ENVIRONMENTAL IMPACT REPORT

**FEDERAL RESERVE BANK
OF SAN FRANCISCO**

FINAL

STATE CLEARINGHOUSE NO. 79040211
JUNE 1979

FIGURE 18 SHADOW PATTERNS
PROJECTED BY THE
PROPOSED FEDERAL
RESERVE BANK BUILD-
ING

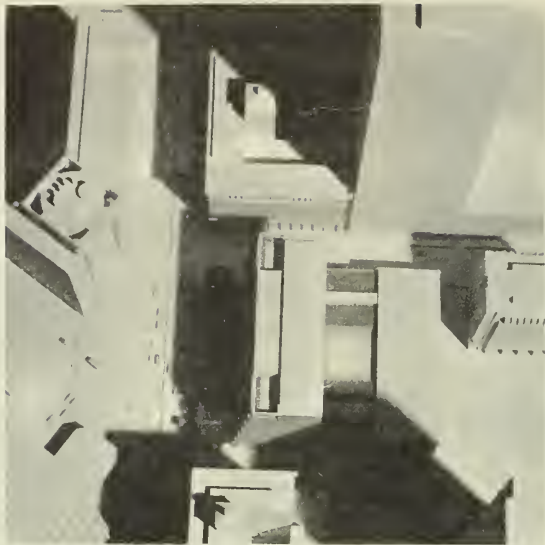
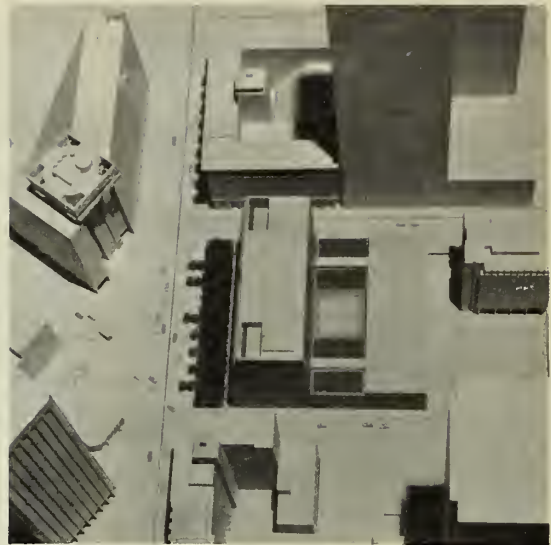
The shadowing effects of the project are described on p. 62 and illustrated in Figure 18. These indicate that the Robert Frost Plaza and the Mutual Benefit Life Plaza would be "partially or entirely shaded by the proposed project at all times in the late fall and early winter months, and that "morning shadows, except in late spring and early summer, would extend across at least the eastern portion of the Mutual Benefit Life Plaza and portions of the Robert Frost Plaza."

The tallest of existing buildings on the site are about one-half the height of the proposed building, but they are not set back 40 feet. By cutting back the shadows of the proposed building as shown on Figure 18, p. 63, by one-half, an approximation of existing shadows would be obtained.

FIGURE 21: VIEW CORRIDOR

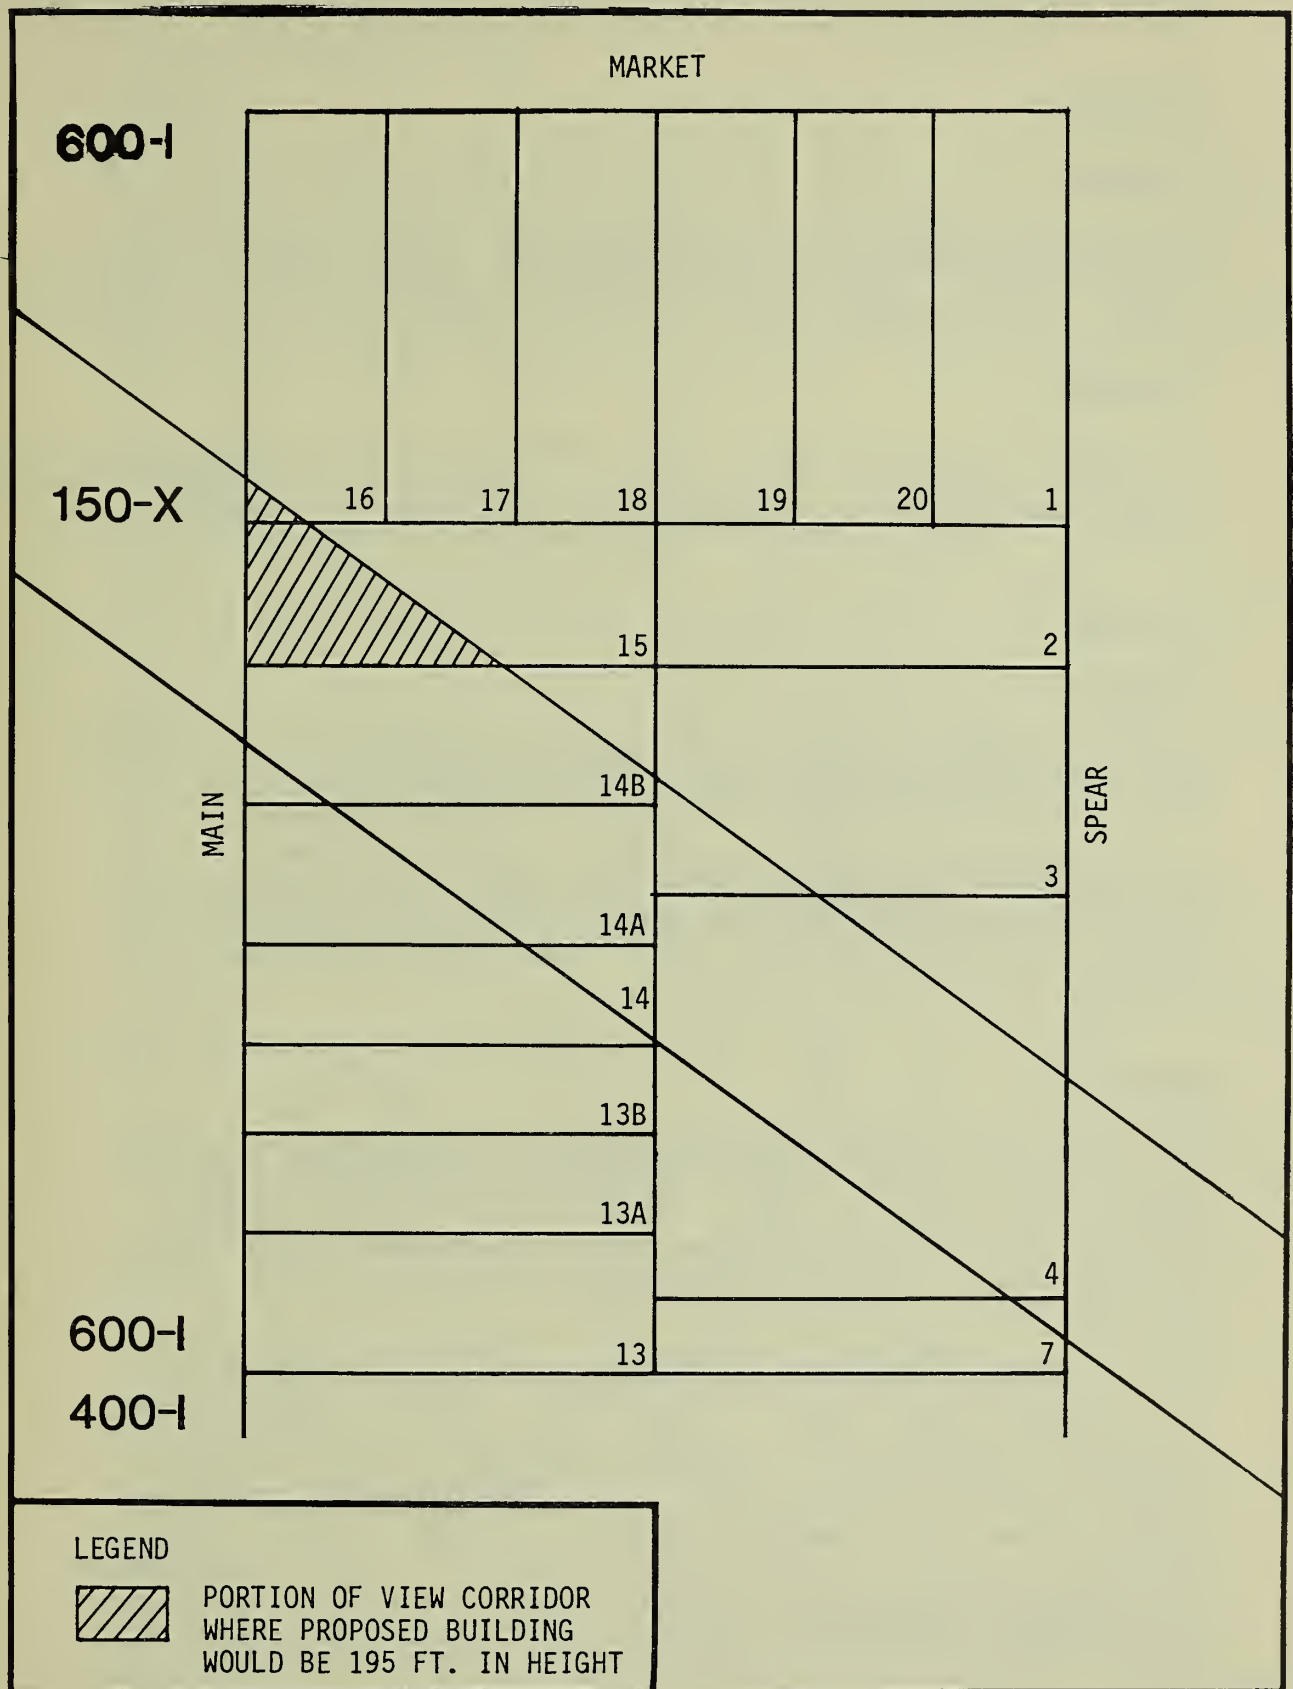
The rear wall of the twelve-story, 195 ft. tower would be 160 ft. from the Market St. property line. The view corridor is 69 ft. wide and runs at an angle across the property as shown in Figure 21 (draft attached). On the Main St. frontage the building would extend 38 ft. into the corridor. The rear wall would extend into the corridor for a depth of approximately 50 ft. The total floor area in this corridor above the 150 ft. elevation would be 2,520 sq. ft. If this area were squared off and omitted from the building above the 150 ft. elevation, a new interior configuration would be required, moving an elevator and service core into portions of larger functional spaces.
